WOODSPRING SUITES

AT RICHMOND RD

INITIAL SITE DEVELOPMENT PLAN
OVERLOOK HOTEL

ARB PRELIMINARY SUBMISSION
DECEMBER 22, 2021

LANDSCAPE PLAN

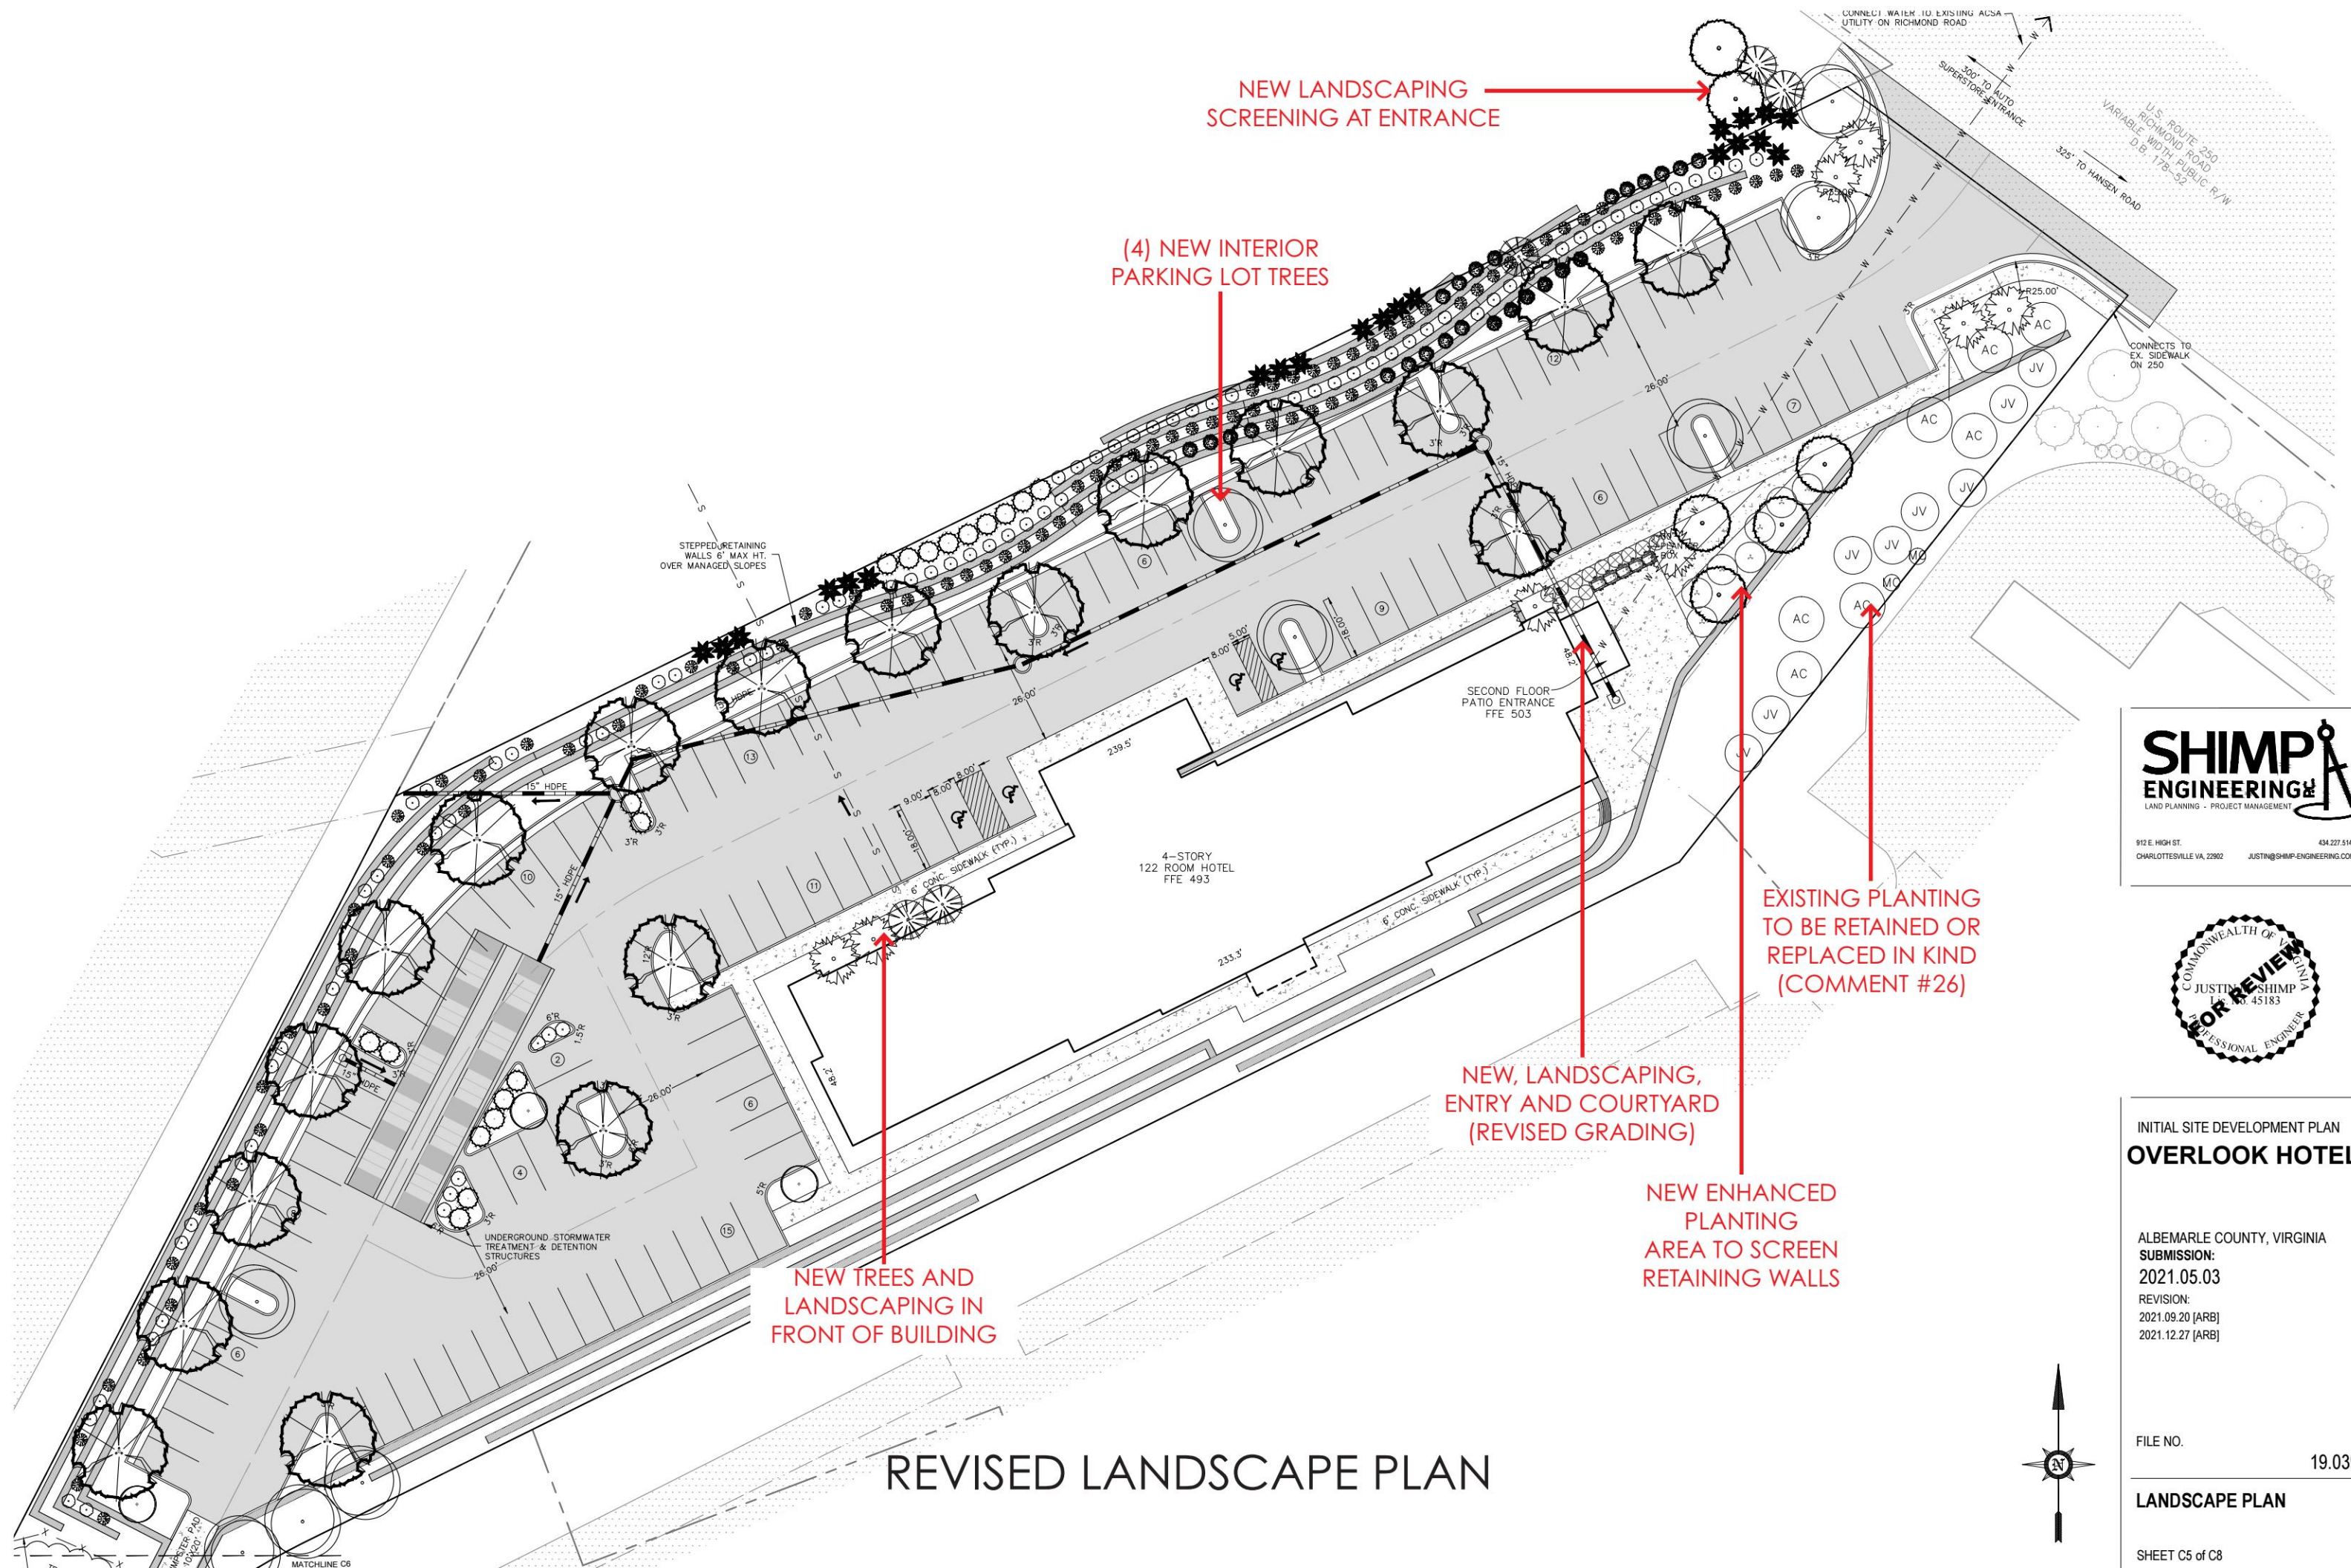
5. Revise the landscape plan to provide additional plantings along the base of the retaining walls visible from the EC to achieve a more appropriate appearance.

6. Revise the landscape plan to provide adequate planting area between the retaining wall and the walkway along the 12-space parking row. Provide medium trees, 2 1/2 caliper at planting, at 25' on center, in this planting area.

8. Provide large perimeter parking lot trees, 2 1/2" caliper at planting, at 40' on center.

9. Revise the landscape plan to provide 4 additional trees to meet the interior parking area landscaping requirements.

10. Revise the landscape plan to provide trees along the front of the building.

15. Revise the landscape plan to mitigate the visual impacts of the terraced retaining walls.

RESPONSE: A mixture of evergreen trees, shrubs, and ornamental trees are provided at the base of the retaining wall. A landscaping/grading/construction easement is to be obtained from the adjacent property owner. These easements will be provided prior to final site plan approval.

RESPONSE: Comment received. Medium trees, 2 1/2" caliper, are to be planted 25' on center along the pedestrian walkway, adjacent to this 12-space parking row.

RESPONSE: Comment received. Additional parking lot trees are provided. Please see the revised landscape plan.

RESPONSE: Comment received. Please see the revised landscape plan.

RESPONSE: Ornamental trees are now proposed along certain areas of the building front. Please note that the grading necessitates a retaining wall along the portion of the building front, providing a light well to rooms under grade. Due to these grading conditions, trees are not proposed in this area.

RESPONSE: The landscape plan features robust planting measures of evergreen trees and shrubs and ornamental tree plantings to mitigate the visual impacts of the terraced retaining walls.

1
A2.1 ELEVATION- NORTH
1/8" = 1' - 0"

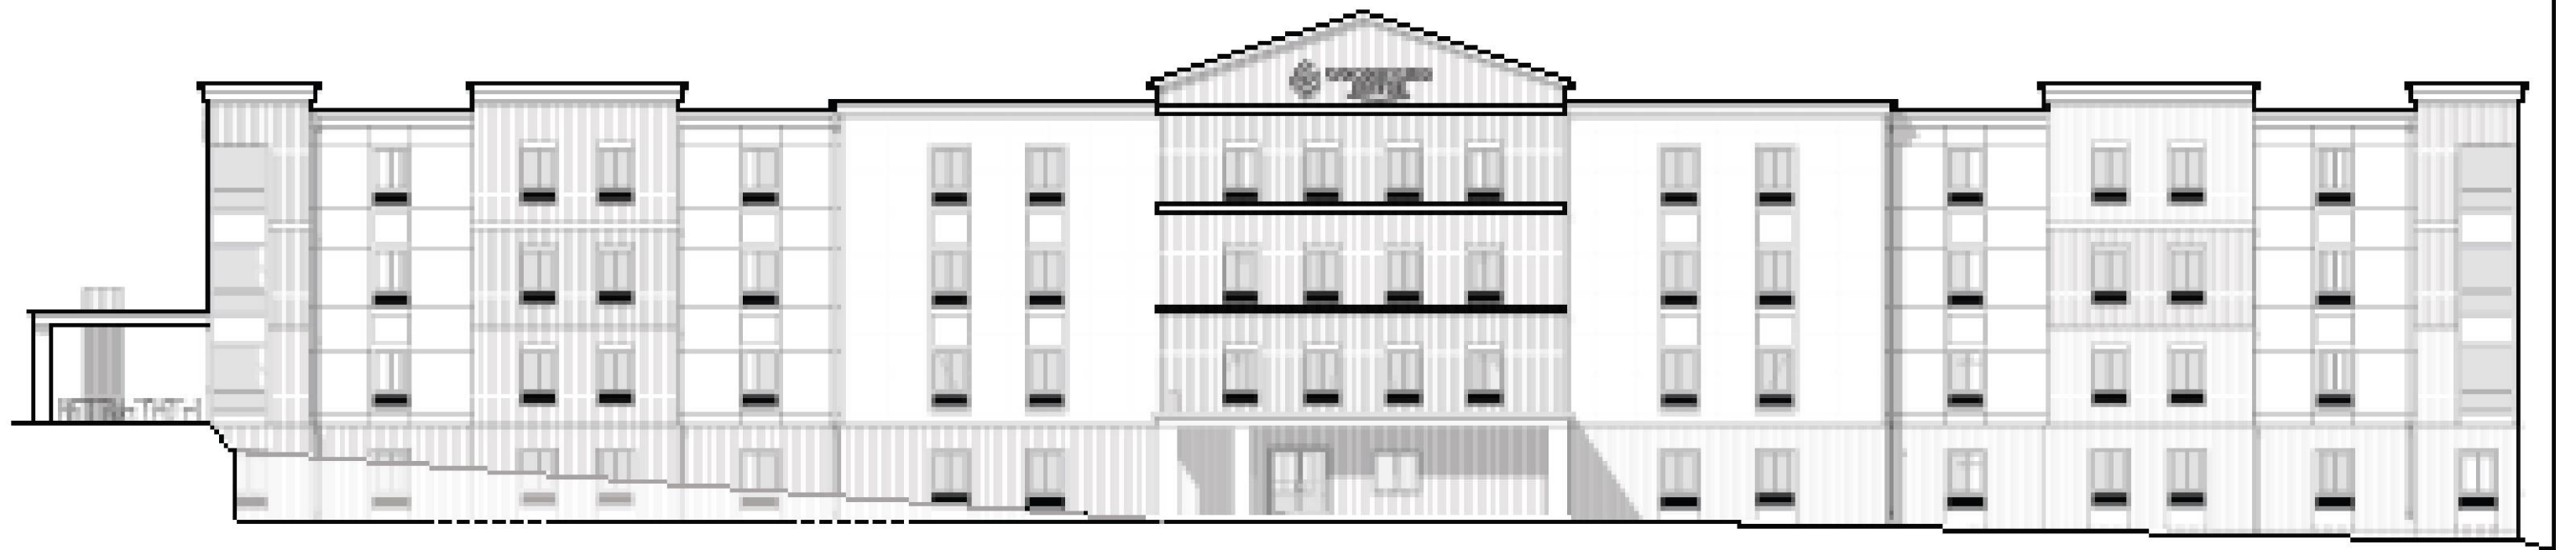
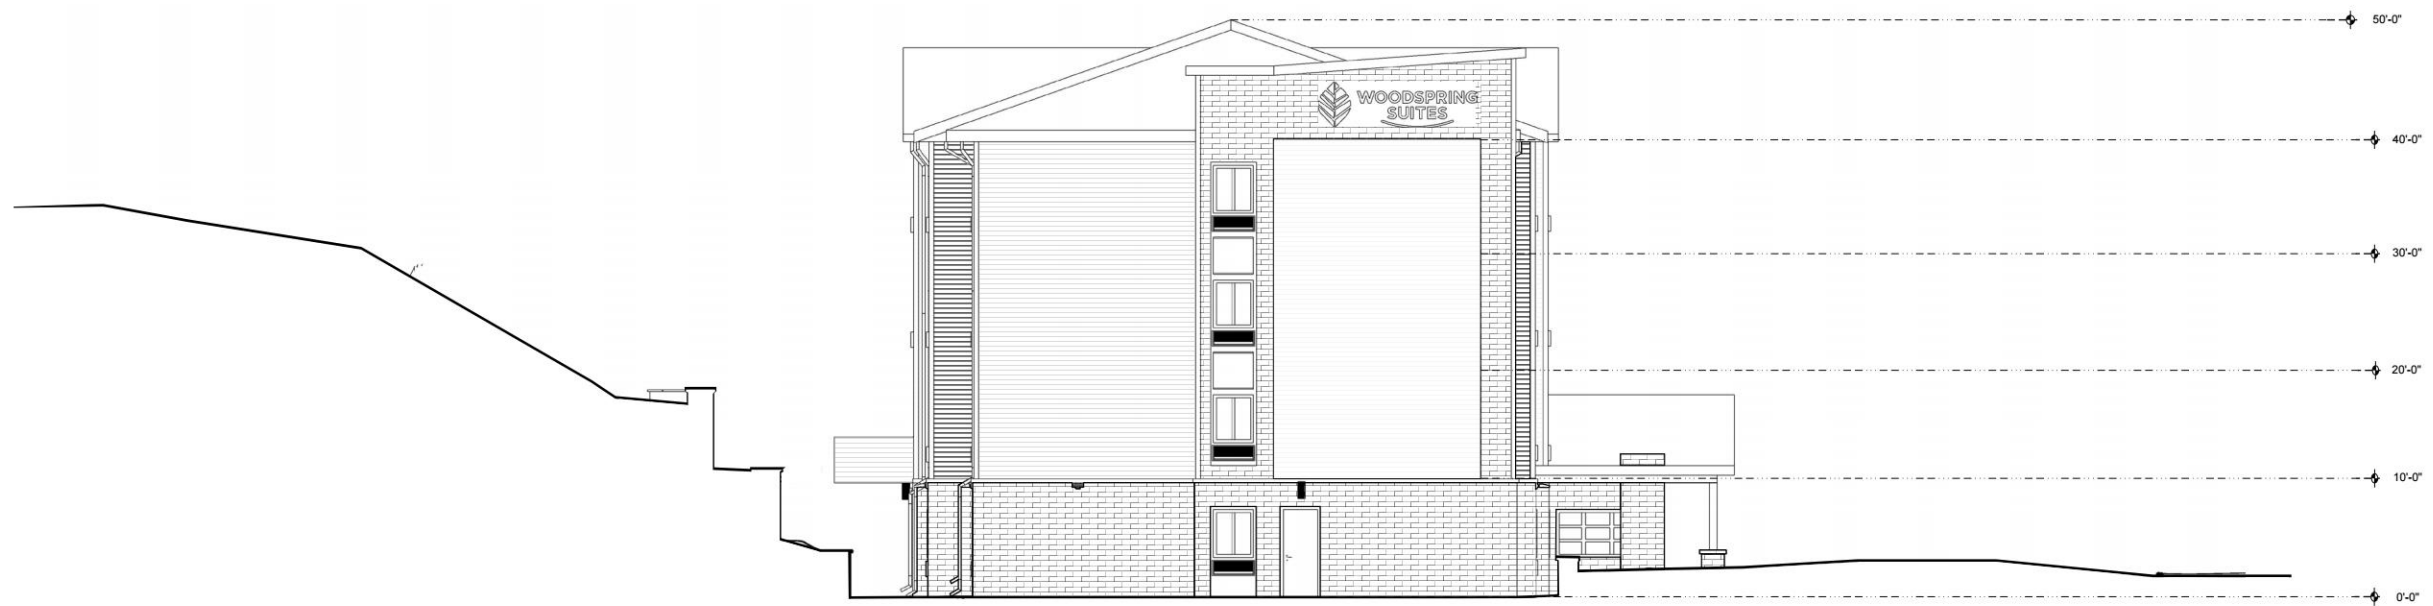
1. Revise the architectural design to make the northern tower address the EC street and possibly further conceal the eastern retaining walls. Adjust the placement, height, materials and detailing of the tower elements to achieve a more cohesive overall appearance for the building.

RESPONSE: This booklet details the significant revisions to the architectural design, per County staff and Board's comments. In general:

- **The architectural design of the building has been adjusted to more appropriately address the Entrance Corridor.** Corner glazing has been introduced at the egress stair to bring transparency and life to the front facade, a new pedestrian oriented canopy element has been added to this front facade, the grading has been significantly revised in this area to present a 3-story building to the Entrance Corridor and create an outdoor patio, and significant landscaping has been added in the front of the building. The "monumental" aspect of the end tower elements has been minimized through the introduction of a flat roof, in lieu of the monopitch roof form previously submitted.

- **The architectural design has been revised to break down large blank areas.** Brick vertical elements have been incorporated in several instances: the bookends and central gable forms have been converted to brick in lieu of lap siding, and additionally, new intermediate brick tower elements have been introduced to limit the length of lap siding runs. We've also introduced EIFS to further break down the massing and provide a variety of materials along the facade.

- **The architectural style has been revised to a more legible, modern, cohesive design.** The canopy element has been redesigned to eliminate the exposed wood beams and gable roof form. Hipped roof forms have been revised to incorporate flat roofs that help emphasize the building materiality/vertical towers while breaking down the scale / length of the eave line. The flat roof also minimizes the overall scale, height, and mass of the building. Simple building elements have been enriched with vertical brick banding at floor levels and soldier courses above window headers. A full size brick will still be utilized at the project base, creating a water table before transitioning to thin brick above the first floor.

SIDE PERSPECTIVE
19

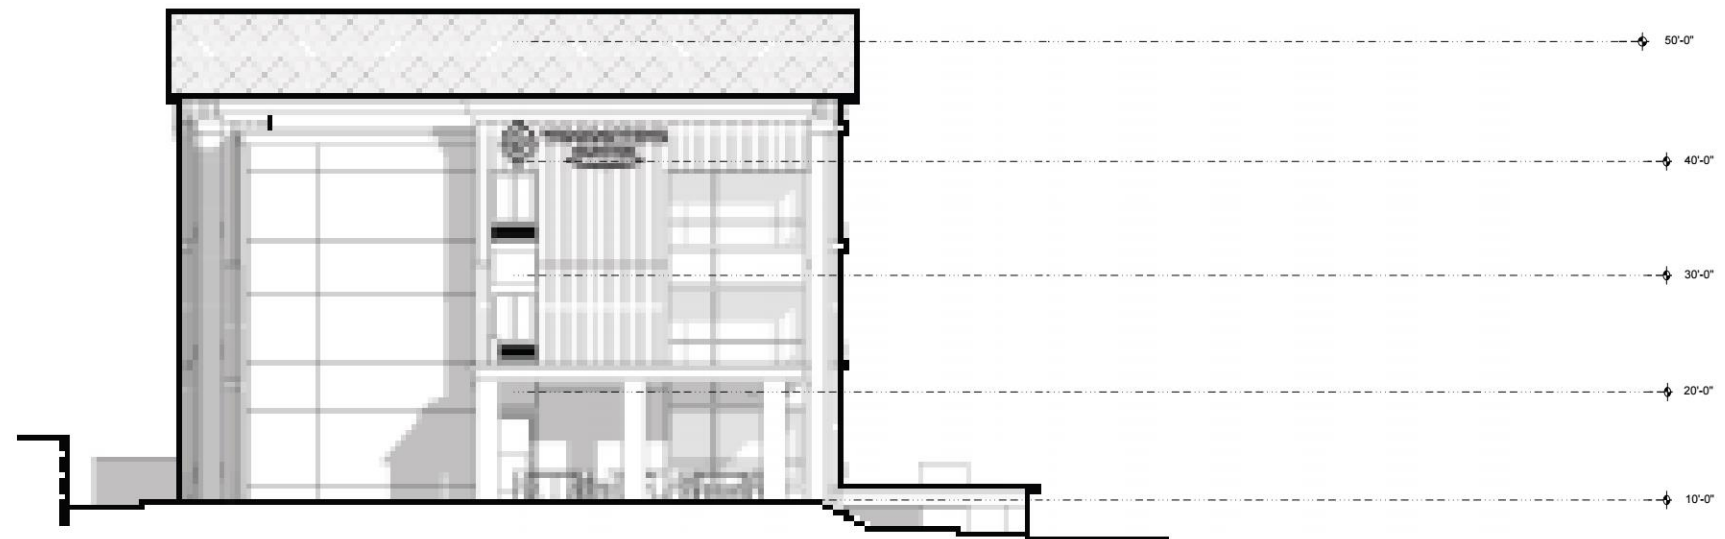
20. Provide a perspective view that shows the retaining wall east of the site entrance with those at the north end of the building.

RESPONSE: A perspective has been added to this booklet.
